**PRELIMINARY DRAINAGE REPORT
FLYING HORSE NORTH PRELIMINARY PLAN AND
FINAL DRAINAGE REPORT FOR FLYING HORSE NORTH FILING NO. 1**

CCES COMMENT RESPONSES

**NOVEMBER 2017
Revised April 2018**

DATE: 1C-25-17
SHEET: 2 OF 4
JOB NO: 1096-11

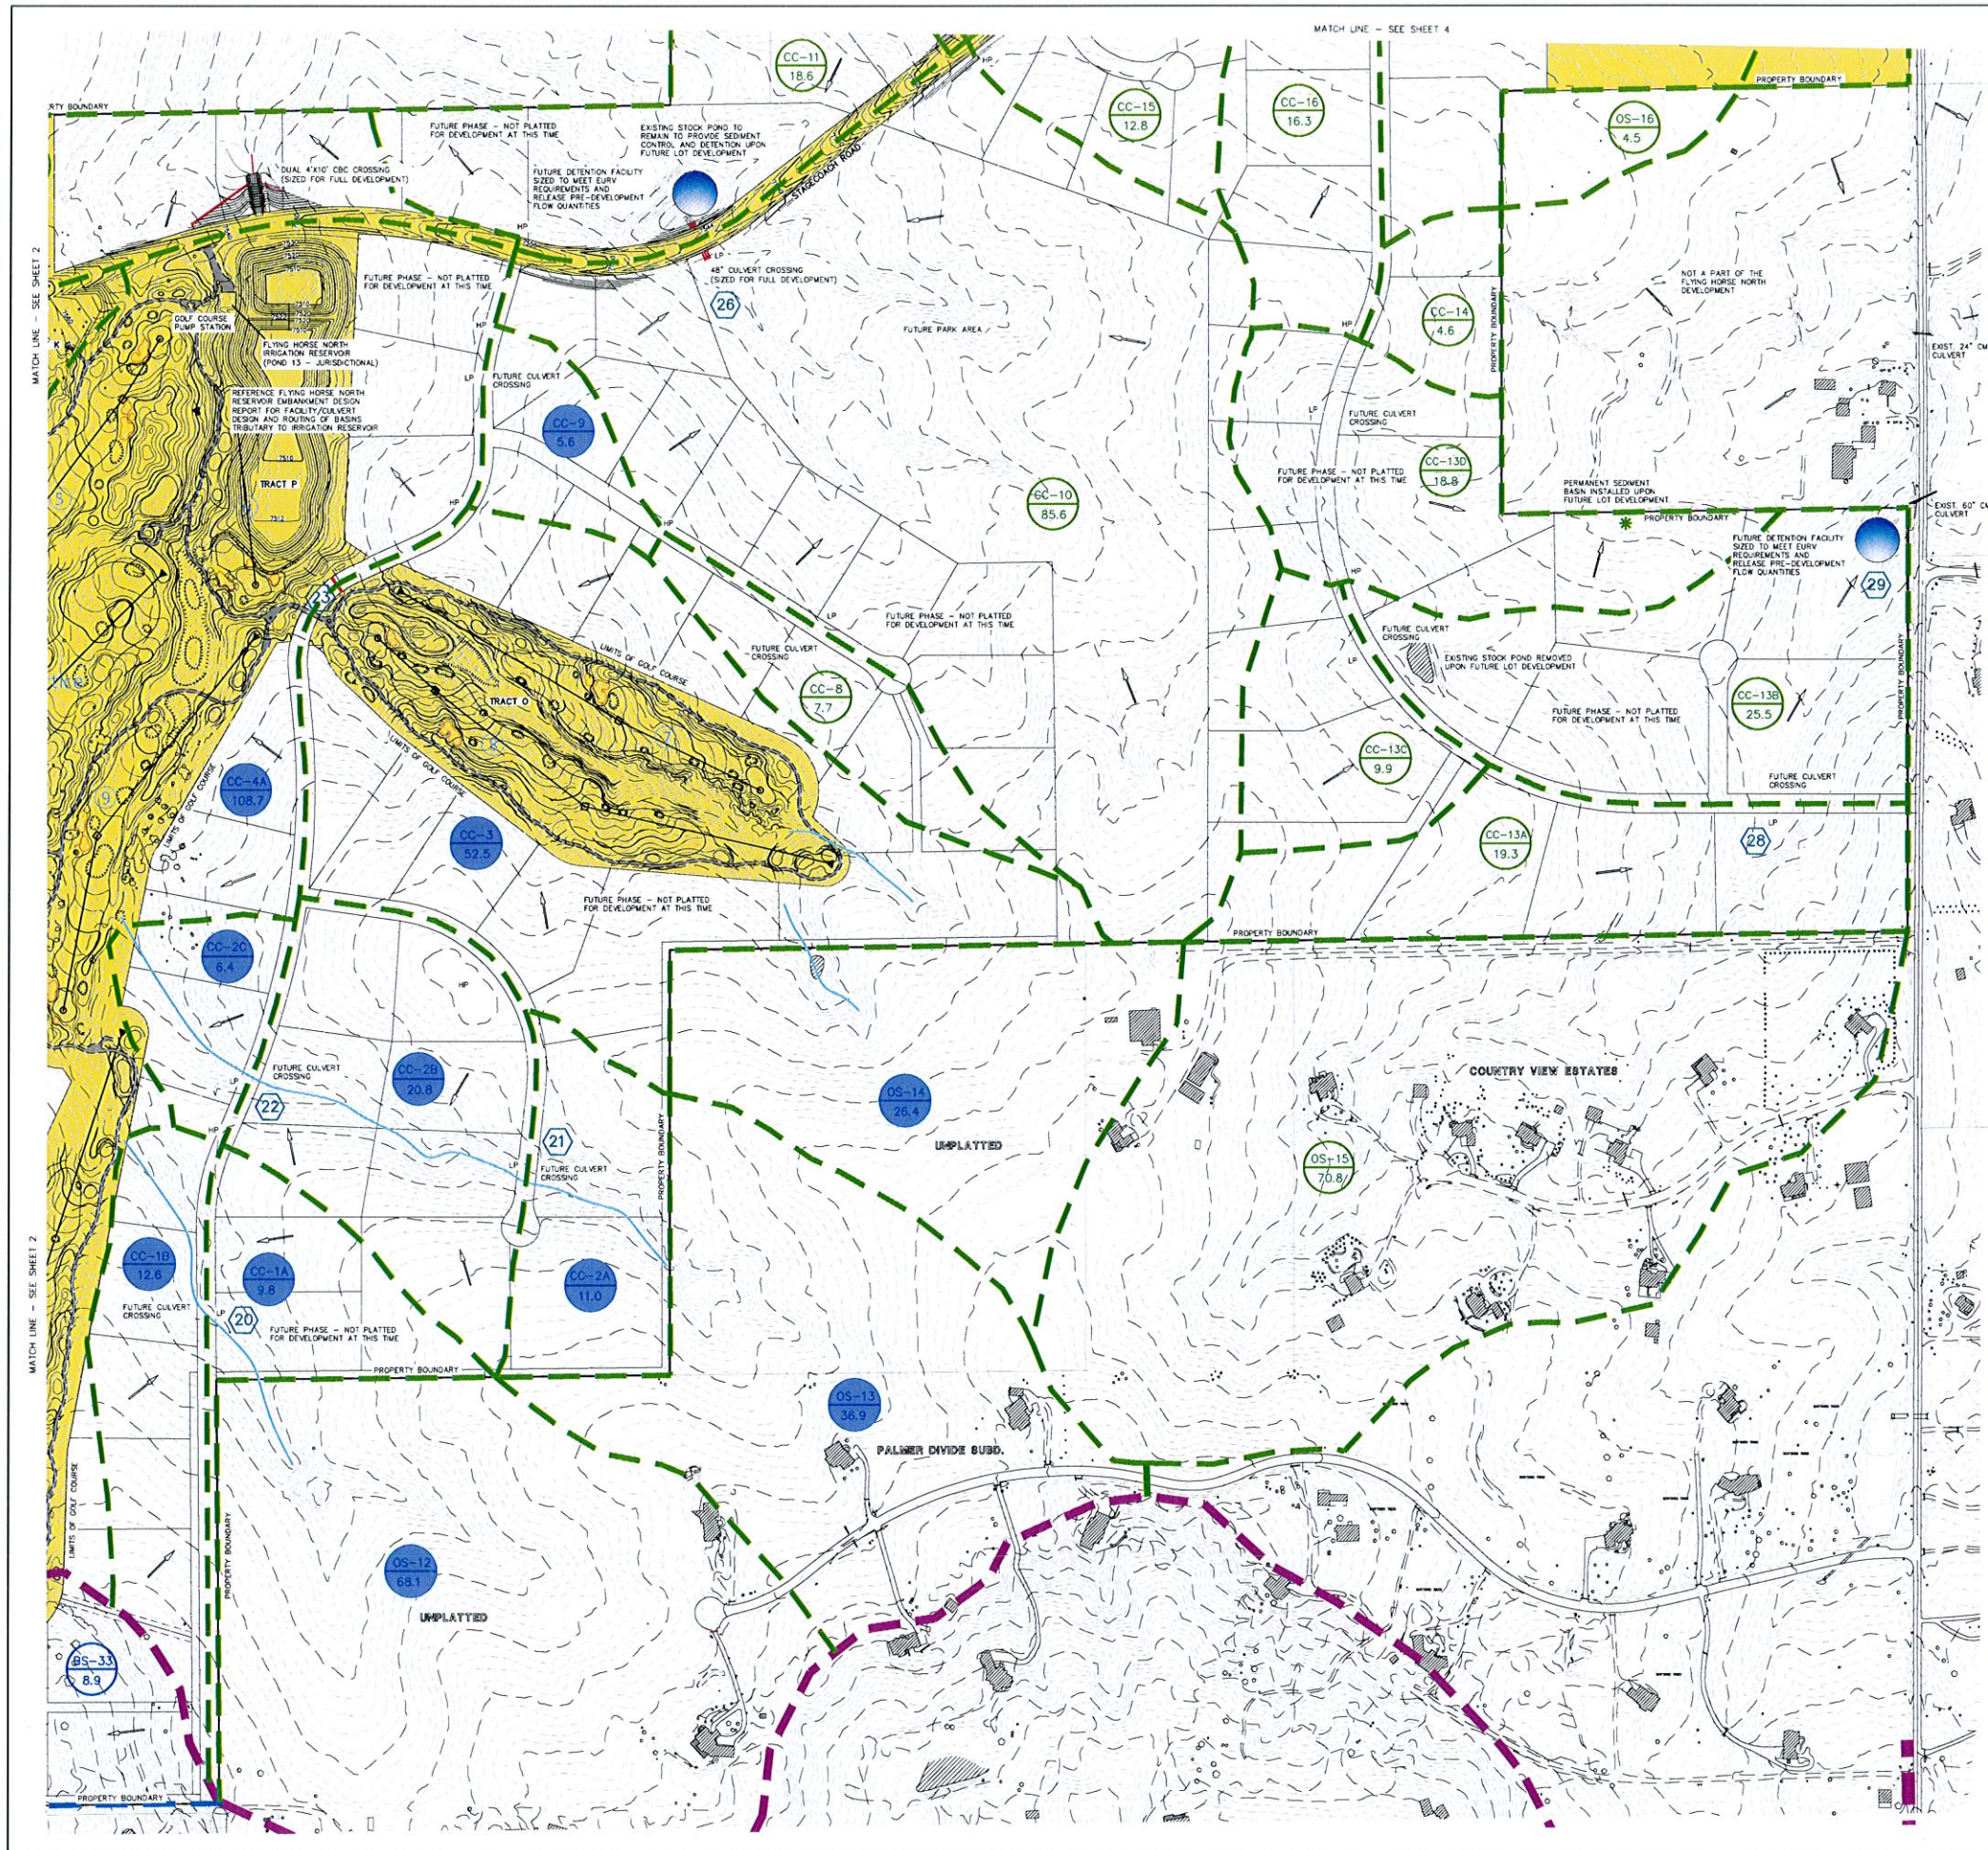
Unresolved
05/09/2018
See review comment on the channel report for the natural channel through lots 58-59

Which plat note # addresses this comment? Staff did not see a note pertaining to culvert sizing.

Resolved
05/09/2018
See revised narrative.

Added
Resolved
05/09/2018

Natural Channel running through lots 58-59

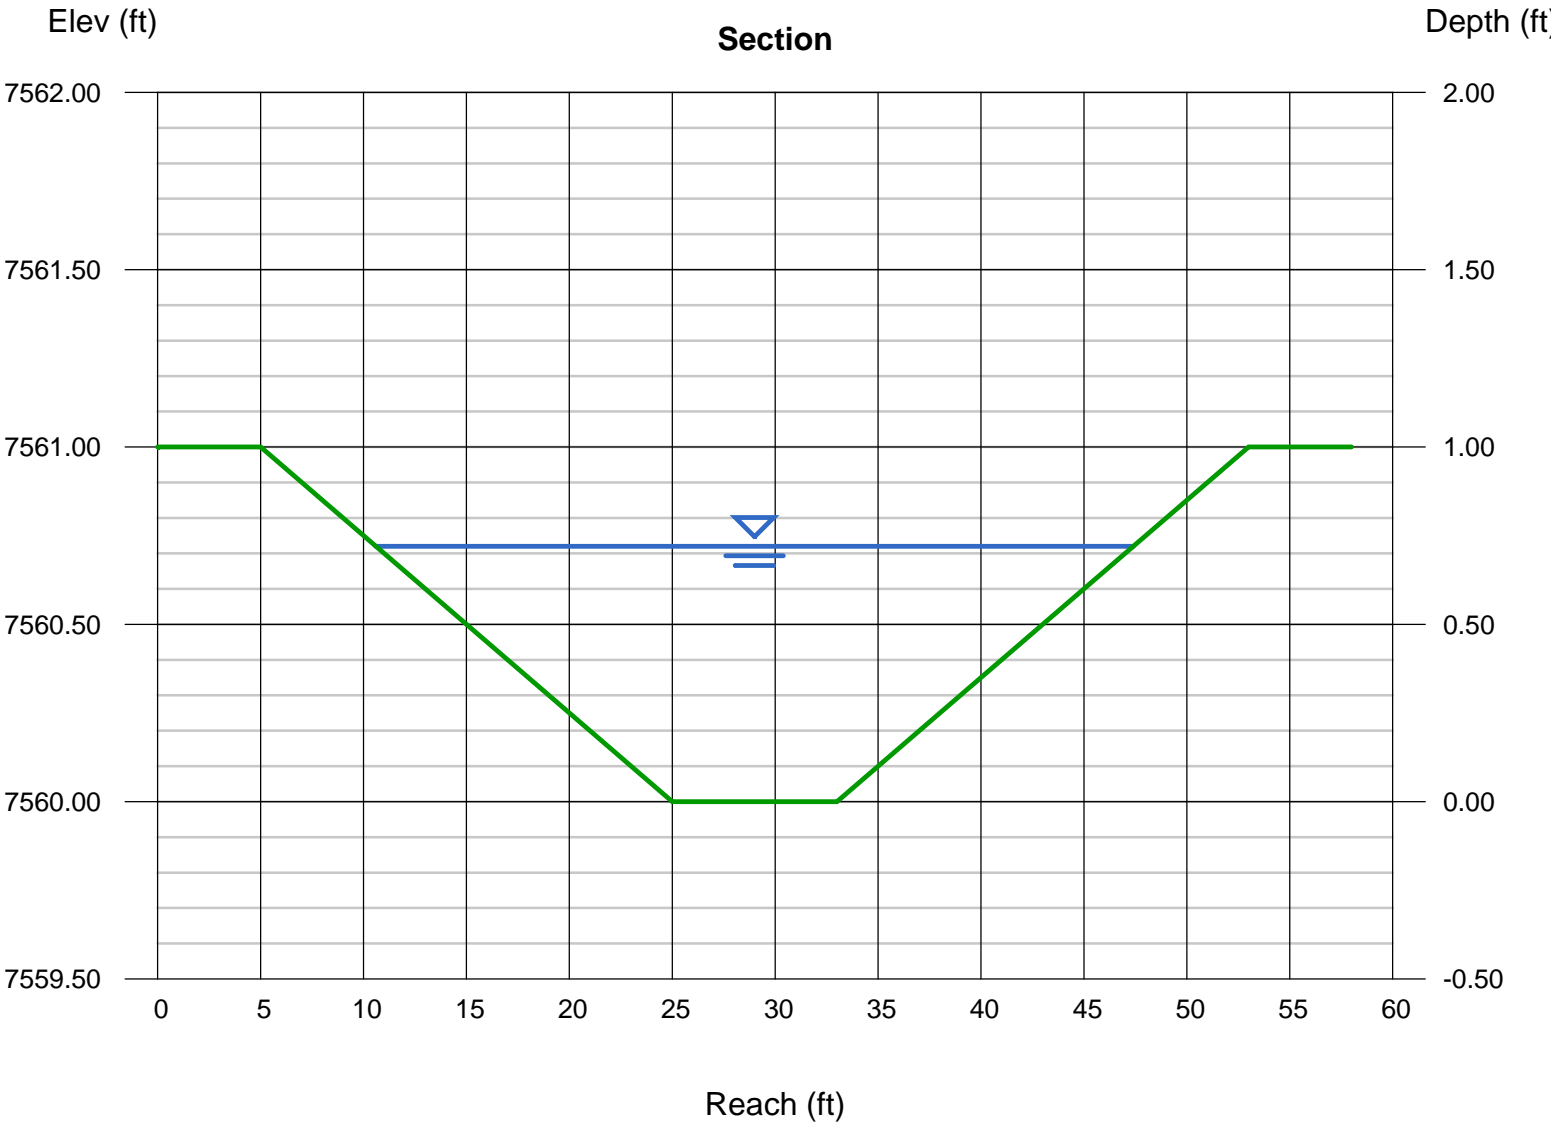
The velocity appears to be greater than permissible velocities for native grass (typically 4 fps for short native grass). Improvements appears to be required for erosion protection. Check the other channel reports and update narrative to discuss the findings.

Natural Channel running through lots 46-50

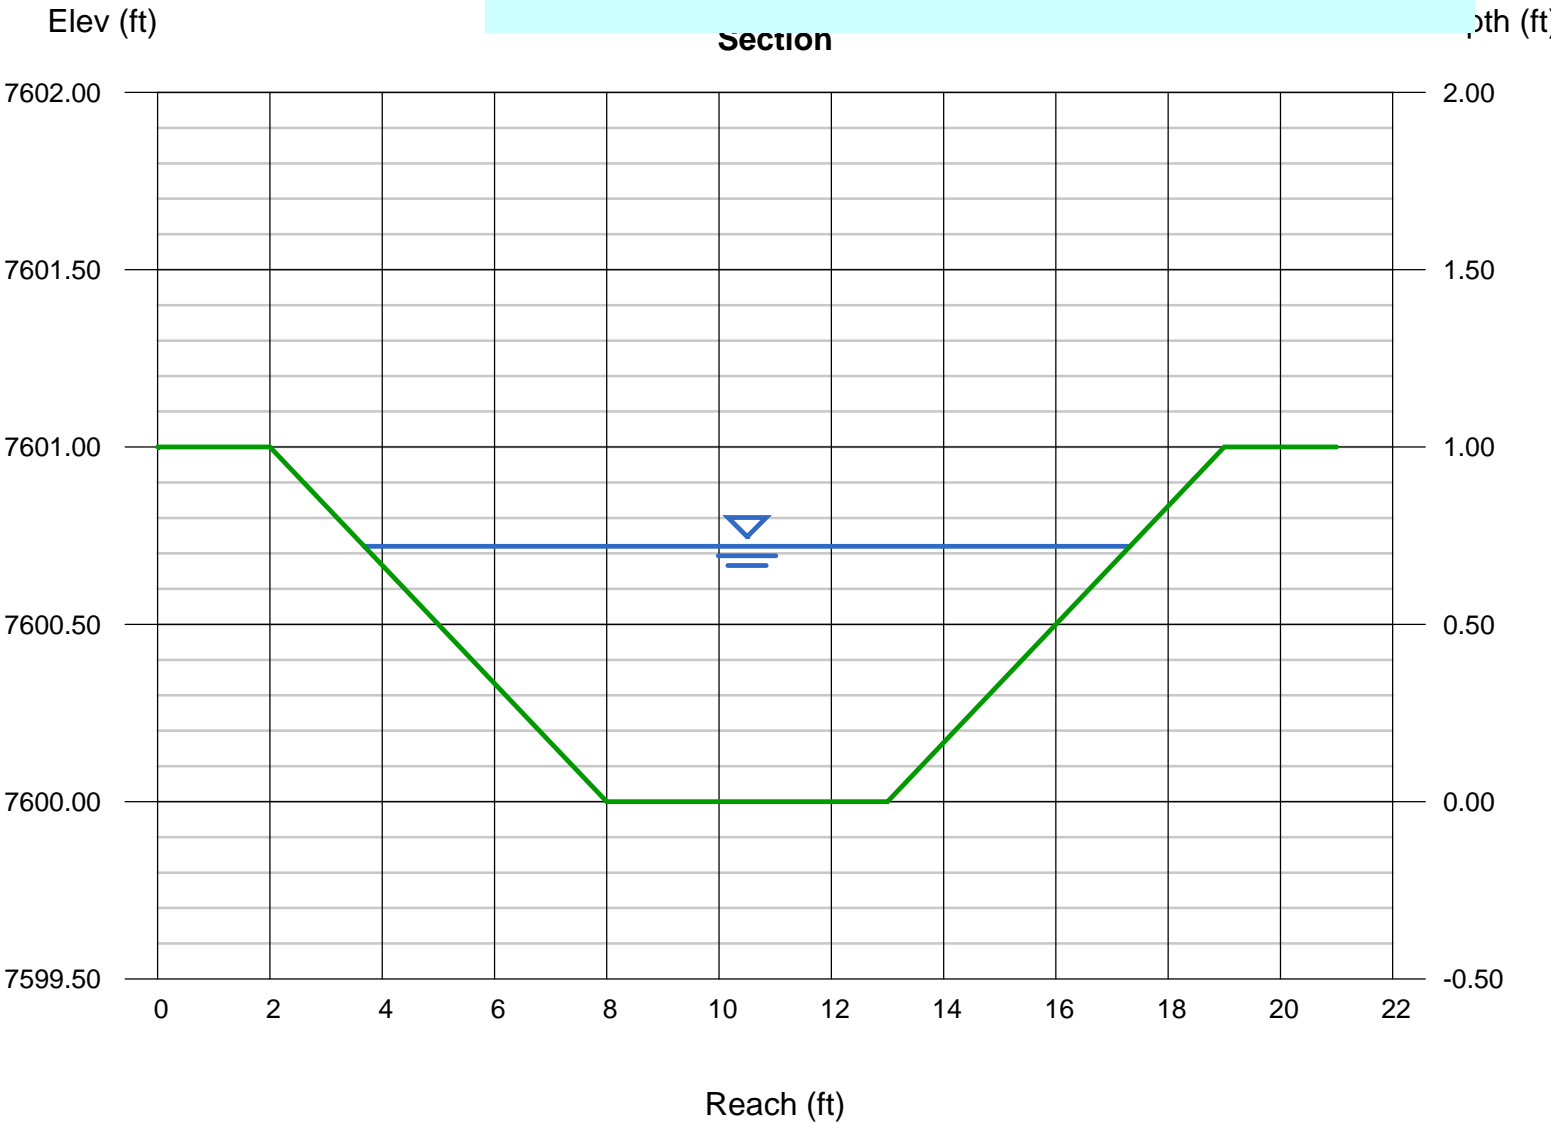
Include the Froude number in all the channel reports. See DCM 6.5.2
